**Proposed SCAA Sports Link ("Place of Recreation, Sports or Culture")  
at South China Athletic Association  
88 Caroline Hill Road in Wong Nai Chung  
- S16 Planning Application Submission –  
TPB Ref.: A/H7/189  
Further Information No. 1**

**(Planning Application No: A/H7/189)**

## **RESPONSE-TO-COMMENT TABLE**

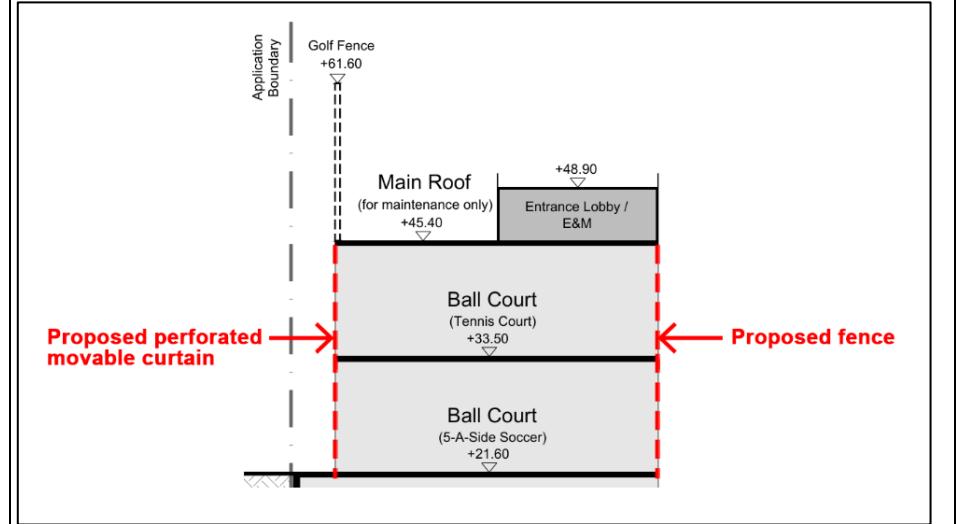
Comments	Response
<p><b><u>Comments from Chief Engineer/Hong Kong &amp; Islands, Drainage Services Department:</u></b> <b>(Contact Person: Mr Keith WONG; Tel: 3101 2376)</b></p> <p><i>1. Drainage Impact Assessment:</i></p> <ul style="list-style-type: none"><li>a. Please advise the proposed pipe size from the stormwater terminal manhole to SMH7021021.</li><li>b. Please demonstrate the proposed pipe size is capable to discharge stormwater runoff from the subject site using the latest design rainfall parameter as stipulated in Corrigendum No. 1/2024 of Stormwater Drainage Manual. Effect of climate change with design allowance in end-21 st Century scenario (i.e. 16%+12.1% = 28.1%) should be adopted according to Corrigendum No. 1/2022 of Stormwater Drainage Manual. The design calculation should also take into consideration of pipe siltation as per Section 9.3 of Stormwater Design Manual.</li><li>c. Appendix 6-1: Please be reminded that Bransby William’s equation for estimating time of concentration is mainly for natural catchment. For urban areas with relatively small catchments, time of concentration is normally not more than 5 minutes. Please review the design calculation.</li><li>d. A runoff coefficient similar to paved area should be adopted if the greening area as mentioned in para. 5.3.1 and presented in the Master Layout Plan is in form of tree pots or planters.</li></ul>	<p>As advised by the Project Team, the proposed pipe connecting the stormwater terminal to SMH7021021 is 375 mm dia.</p> <p>As shown in Appendix 6-1, the total peak runoff from the Application Site due to the Proposed Development has been calculated by adopting the rainfall increase factor due to climate change and design allowance. The total peak runoff after the proposed development has decreased as compared to the existing condition due to the increase of greenery area. No adverse stormwater drainage impact is therefore anticipated.</p> <p>With reference to the Table 2a in Stormwater Drainage Manual Corrigendum No. 1/2024, the extreme intensity for 5 mins duration and 200-year Return Period has been adopted as conservative approach. Please refer to the revised Drainage Impact Assessment in <i>Appendix I</i>.</p> <p>Please be clarified that the horizontal greenery area at G/F is landscaped area, thus runoff coefficient for grassland has been adopted.</p>
